**RE: Request for Major Amendment to a Prior Approved Site Plan – EPC
Amendment to the Plaza at Paseo del Norte Site Plan
Sedona West Apartments, Eagle Ranch Rd NW**

Project #2021-005442
SI-2021-00569 - Site Improvement
Major Amendment to Site Plan

EPC Conditions Response Letter

SEDONA WEST
 EAGLE RANCH ROAD
 ALBUQUERQUE, NM 87114

SHEET NO.
SDP1.1
 OF

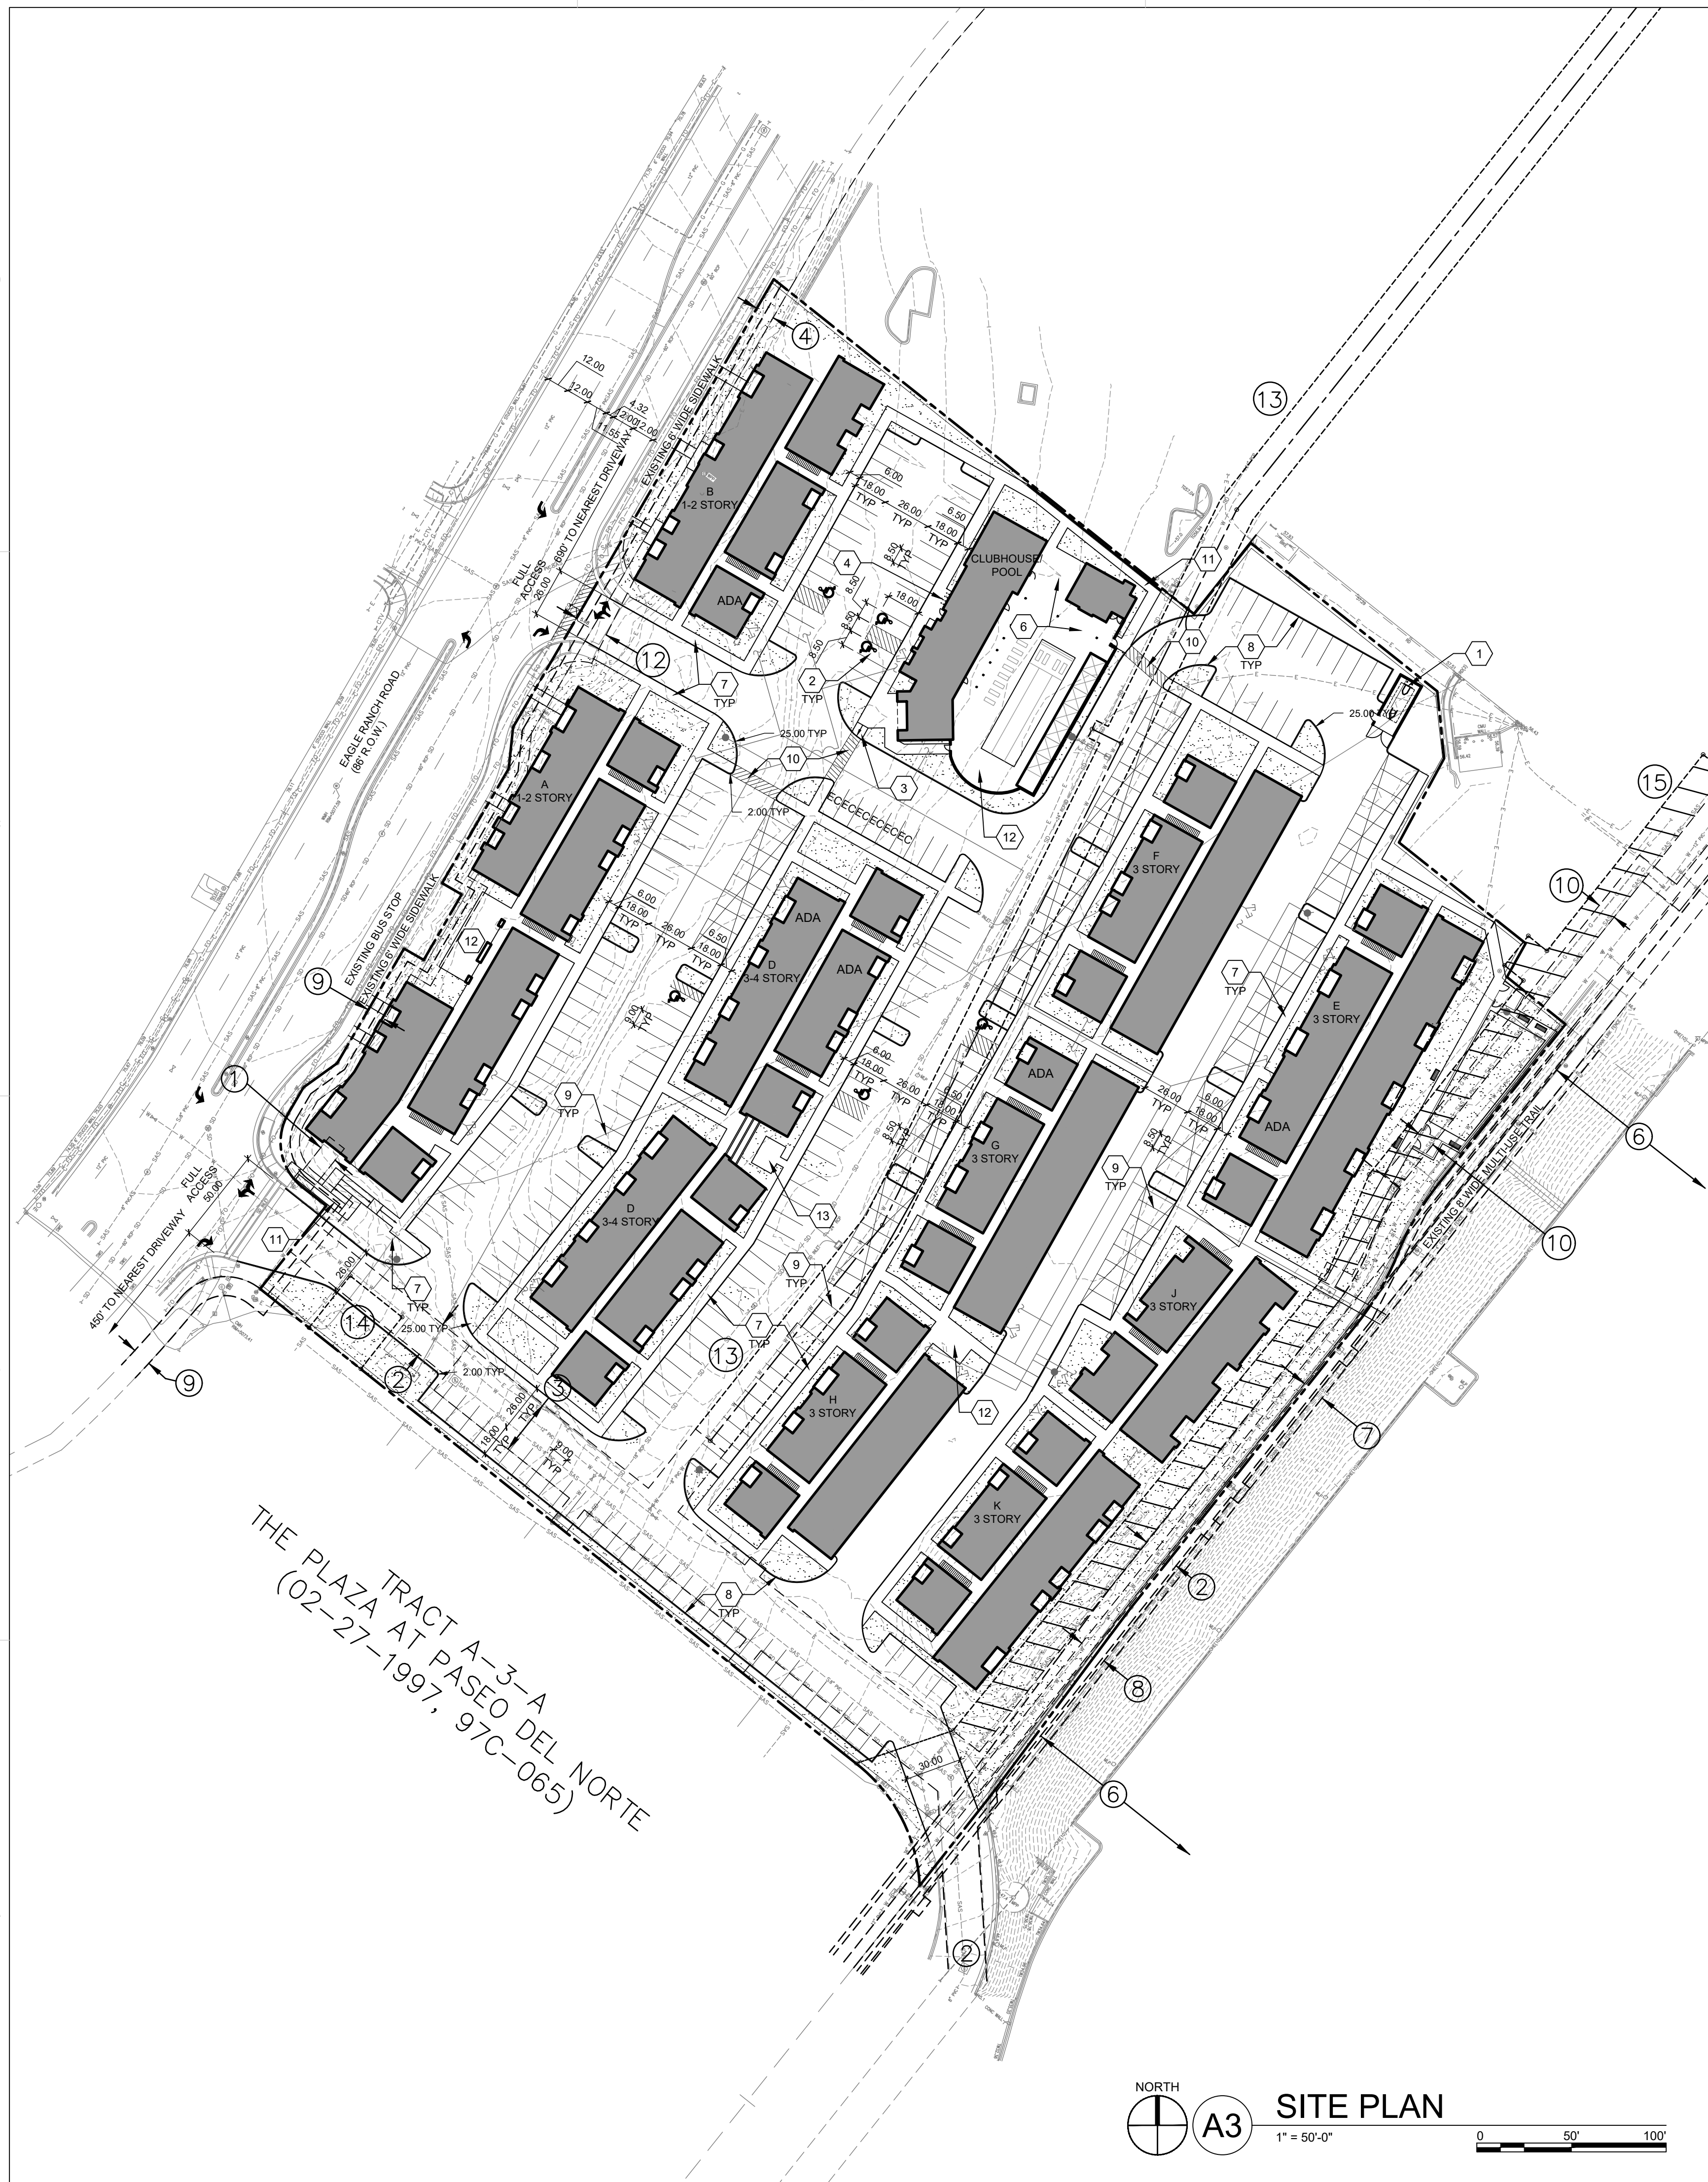
5. Outdoor Gathering Areas
 - A. Indicate where the proposed amenities will be located throughout the development.
 - B. If shade structures and gazebos are to be included, provide details for these structures.

5. Outdoor Gathering Areas
 - a. Indicate where the proposed amenities will be located throughout the development.
 - i. **Response: Keyed notes have been added to the site plan locating the outdoor amenities.**

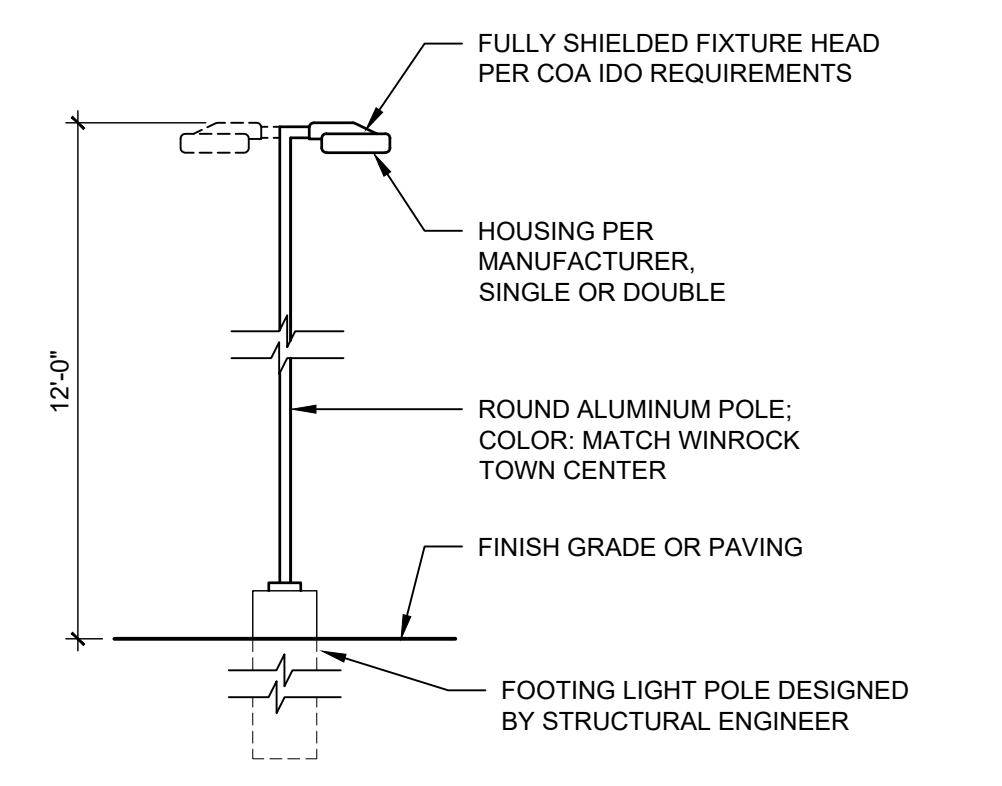
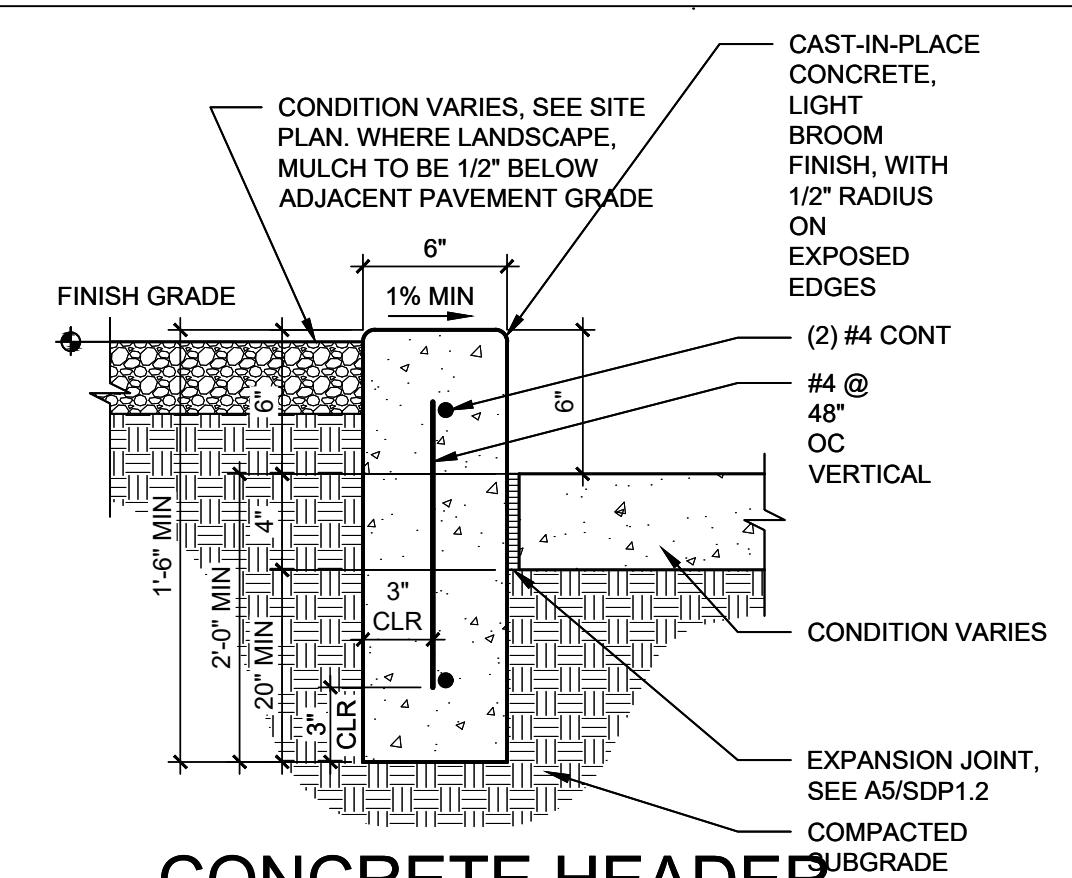
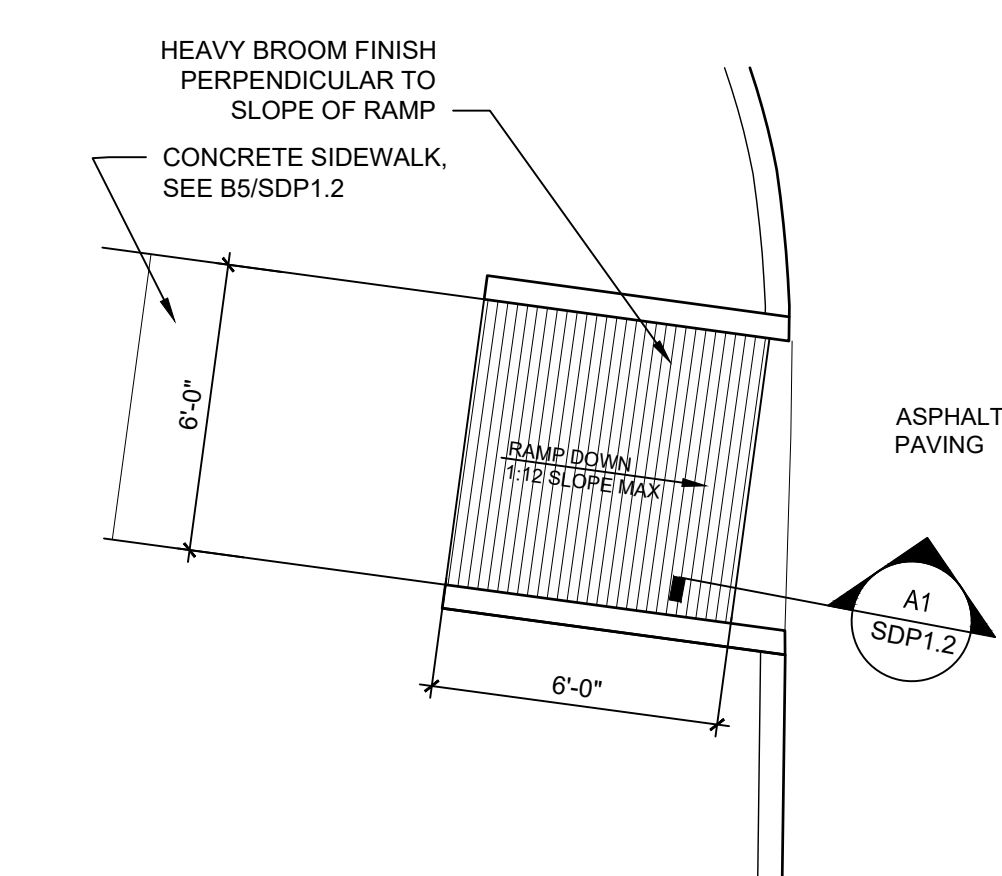
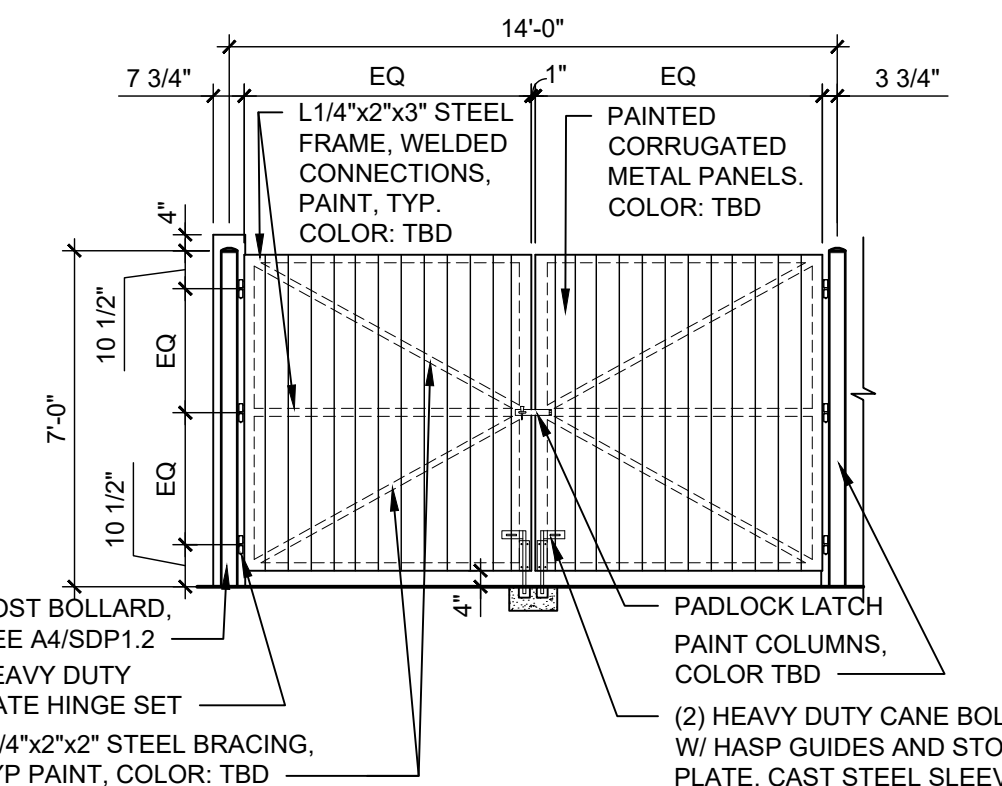
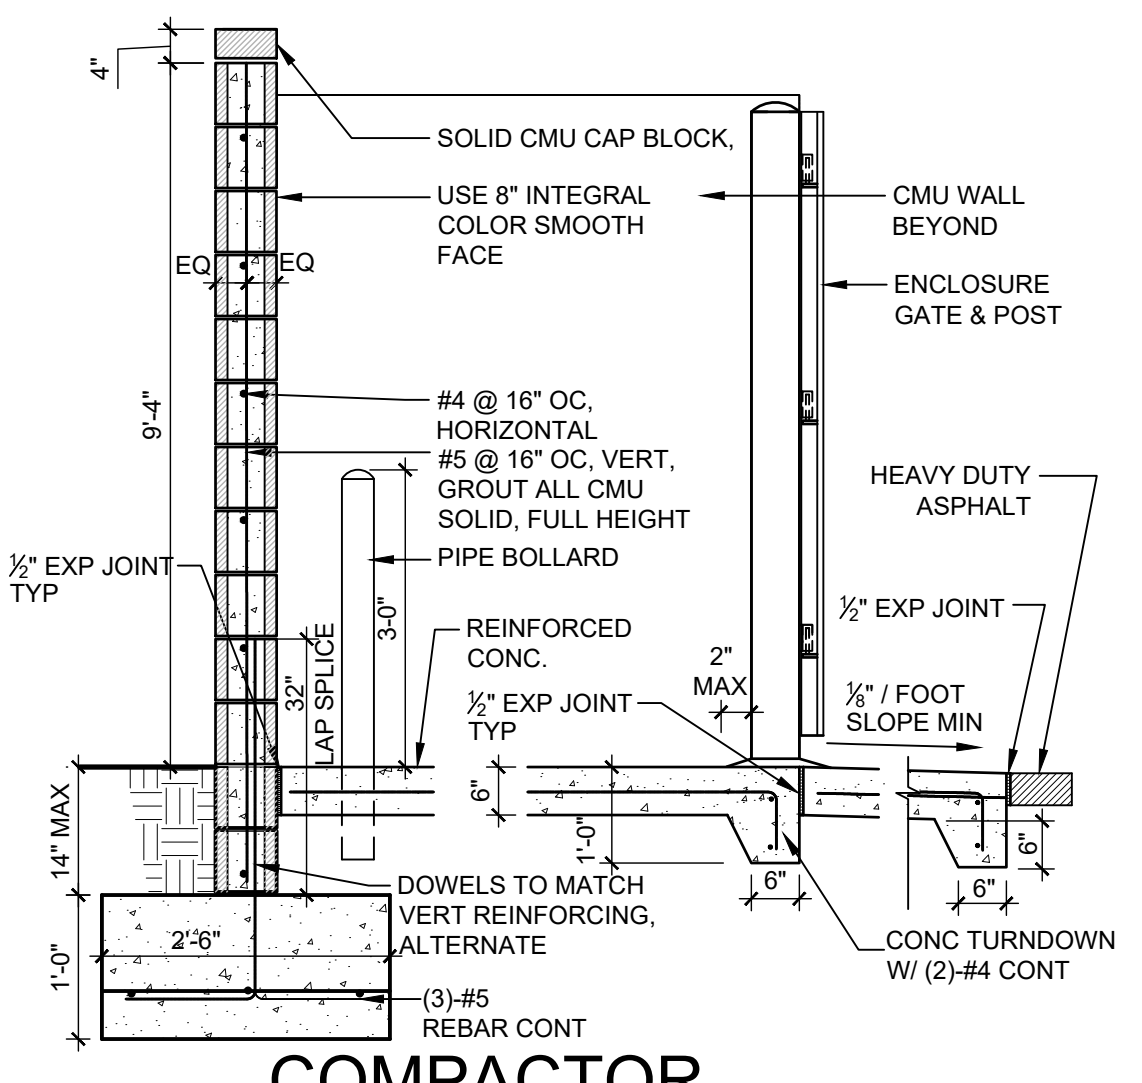
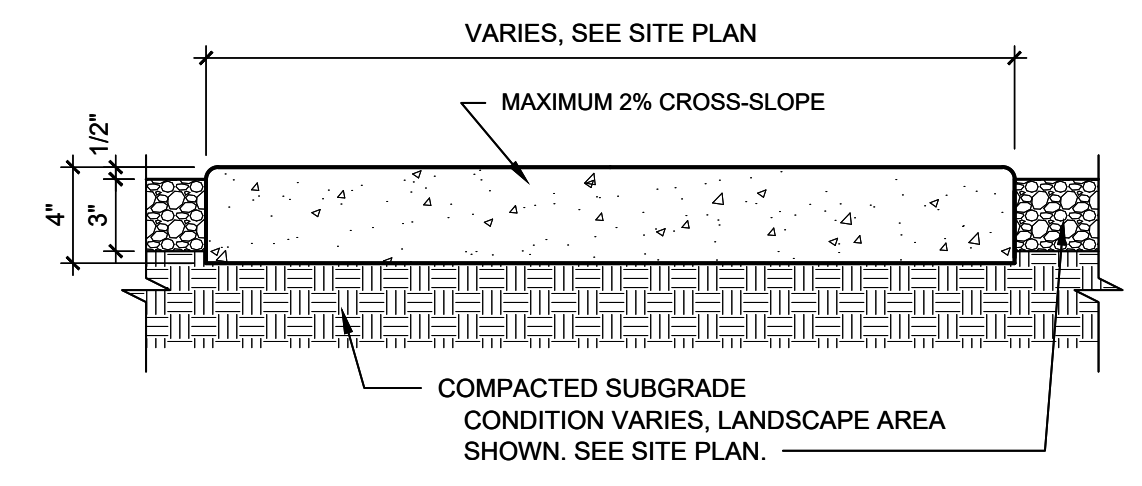
4. Walls & Security
 - A. A detail for the proposed retaining wall shall be provided.
 - B. Wall shall comply with IDO Section 14-6-5-7(E) Walls and Fences – Materials and Design.

4. Walls & Security
 - a. A detail for the proposed retaining wall shall be provided.
 - i. **Response: A detail has been provided on sheet SDP1.2.**
 - b. Wall shall comply with IDO Section 14-6-5-7(E) Walls and Fences – Materials and Design.
